Republik is pleased to present our updated plans for the conversion of the existing Madison Plaza Hotel at 3841 E Washington Avenue into multifamily apartments for final approval with the Urban Design Commission.

Commission Feedback & Repvblik Response:

RENOVATION
PLATO'S MADISON, WI
3841 E WASHINGTON AVE, MADISON, WI 53714

SHEET TITLE
OVERALL EXTERIOR
ELEVATIONS

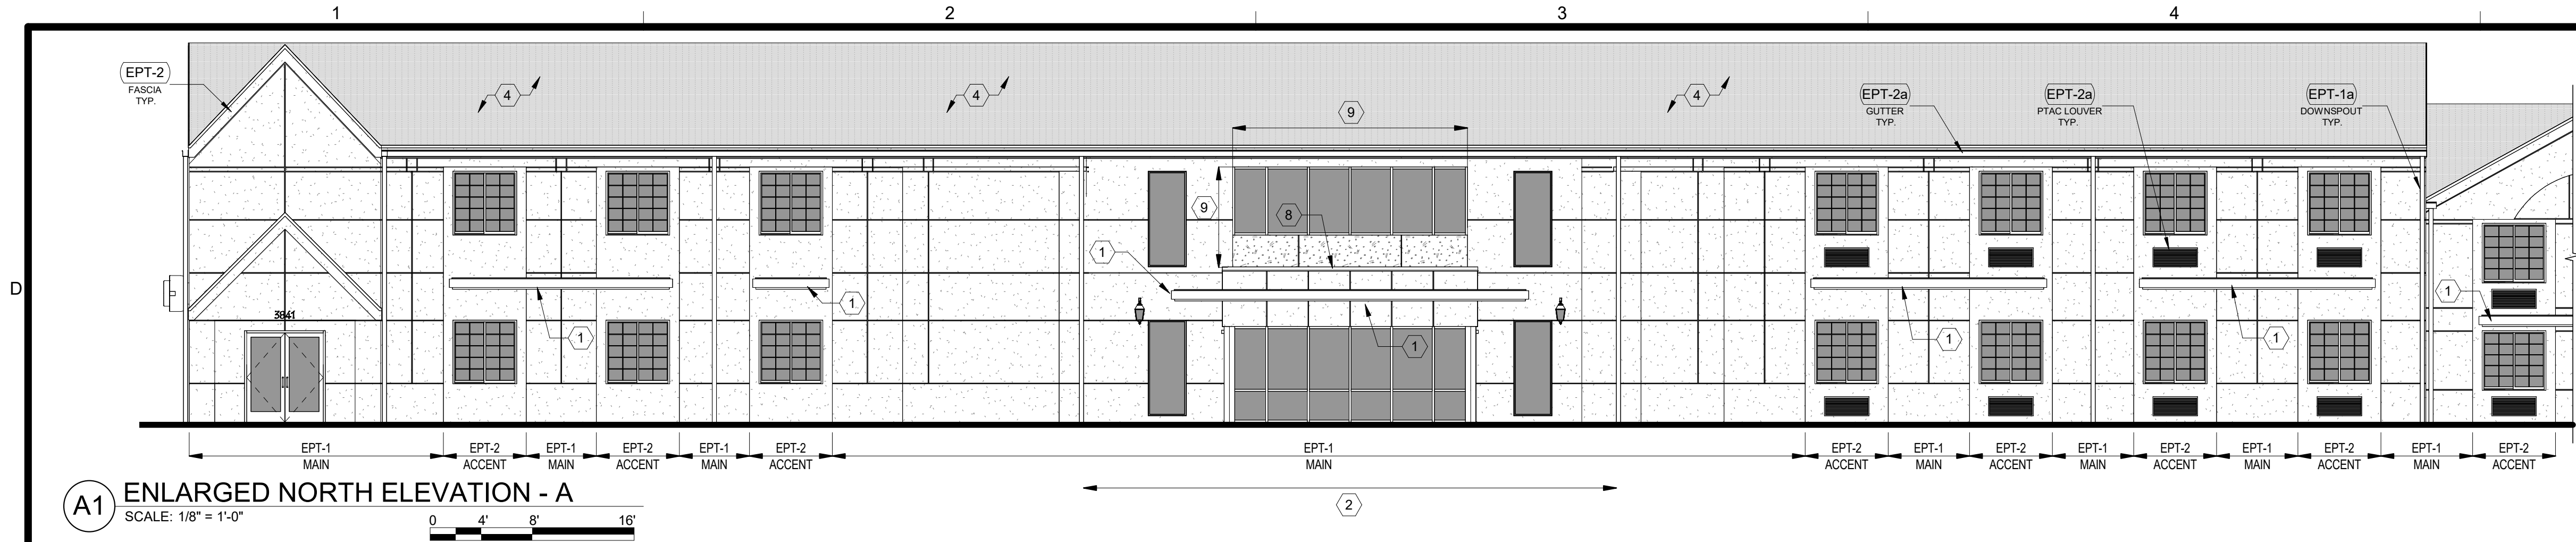
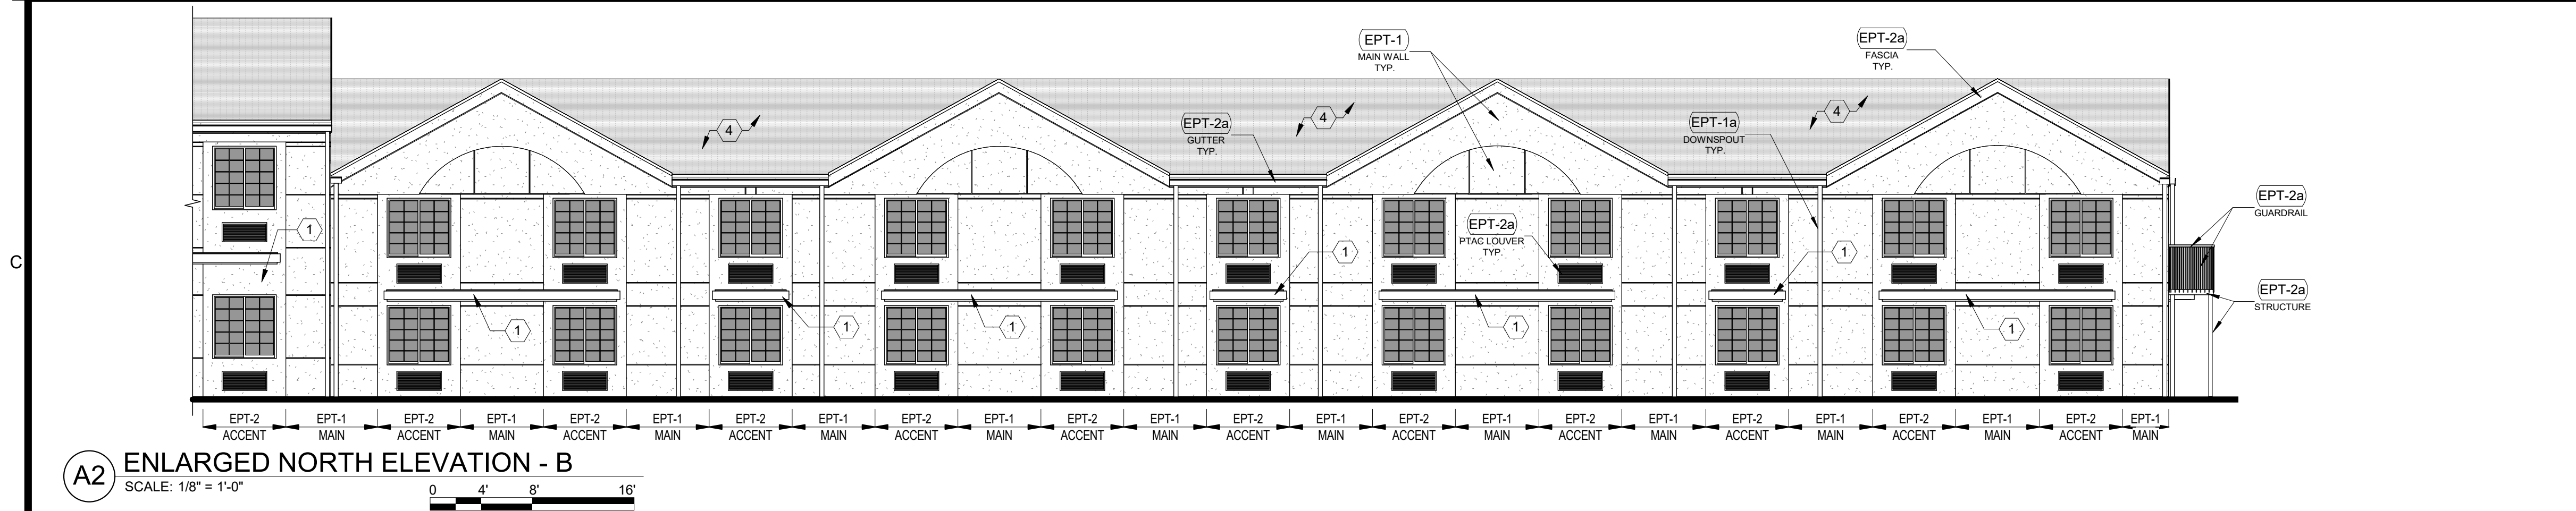
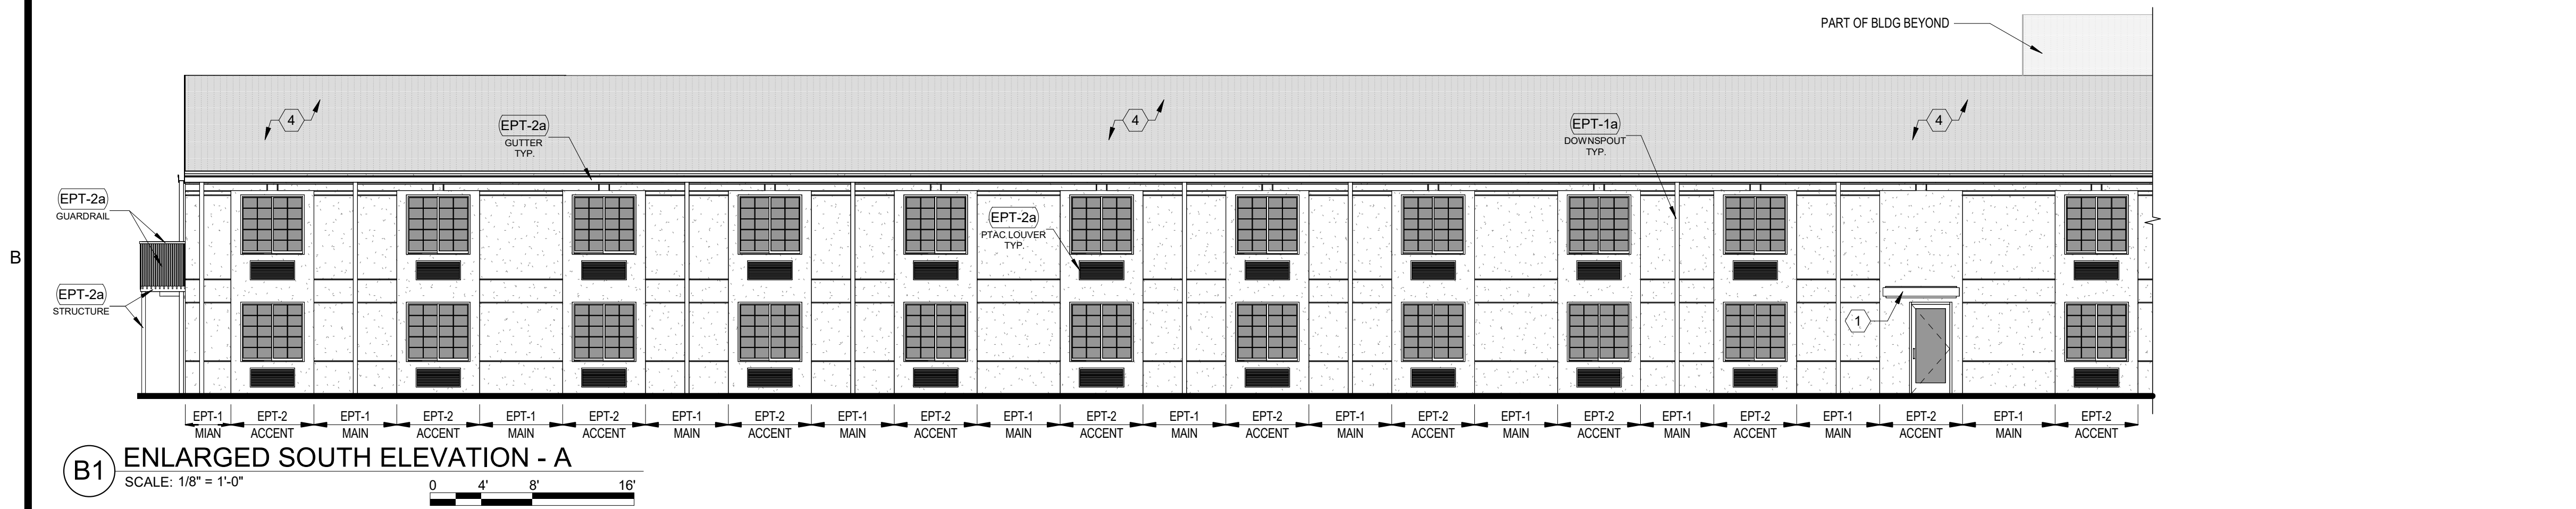
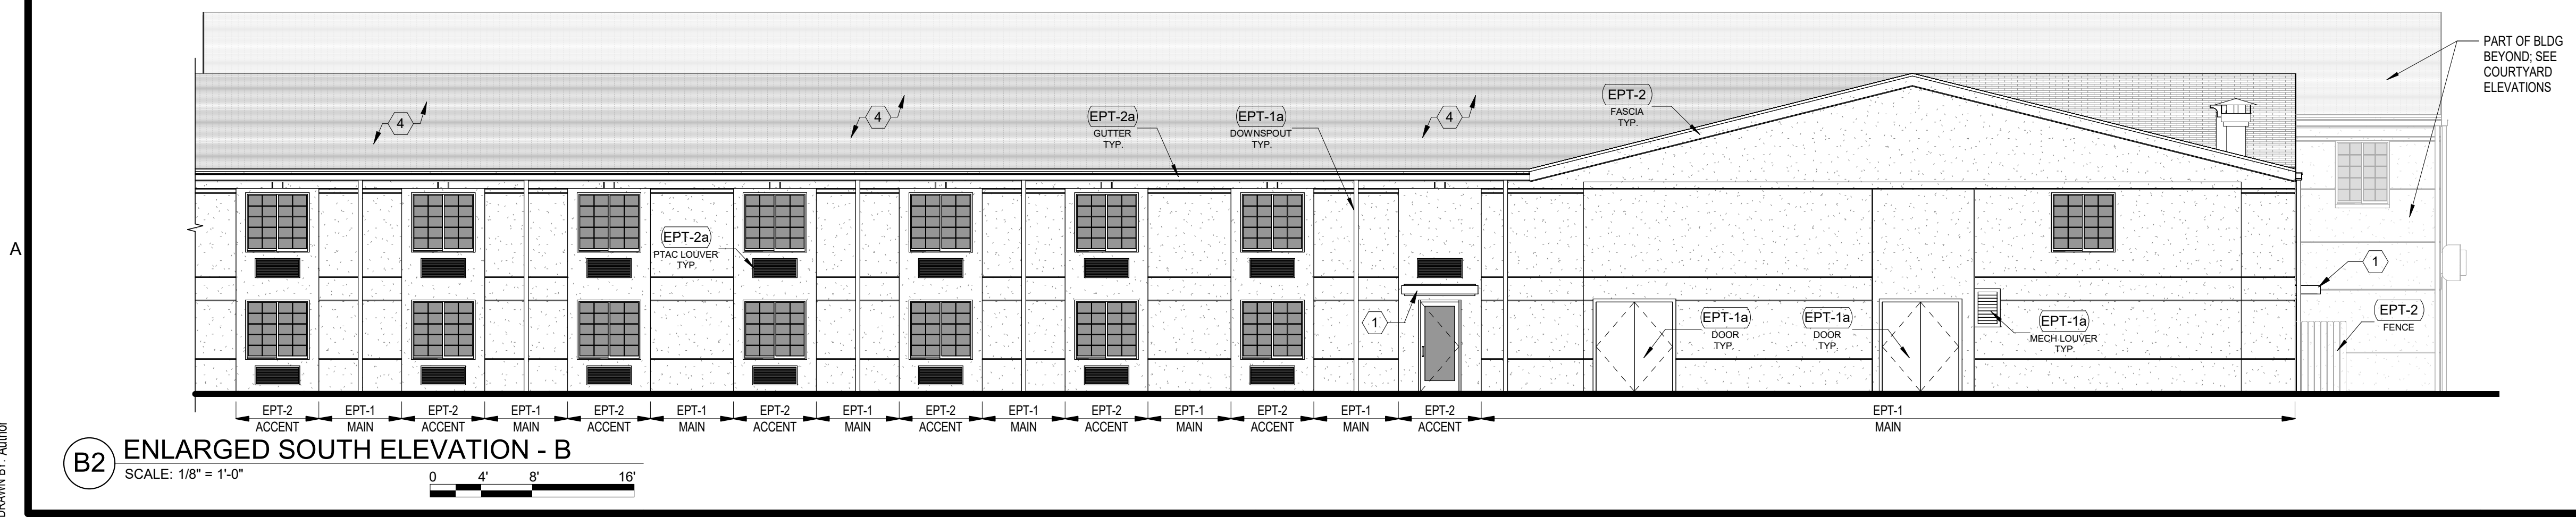
- a. *An updated photometric plan is attached herein.*
3. The applicant shall update the elevations to address architectural comments, including:
 - a. Updating the color of the downspouts and gutters to match the exterior wall color,

- i. *Downspout and gutter colors have been revised to match the surrounding façade.*
 - b. Consideration should be given to downplaying the arches in the building gable ends,
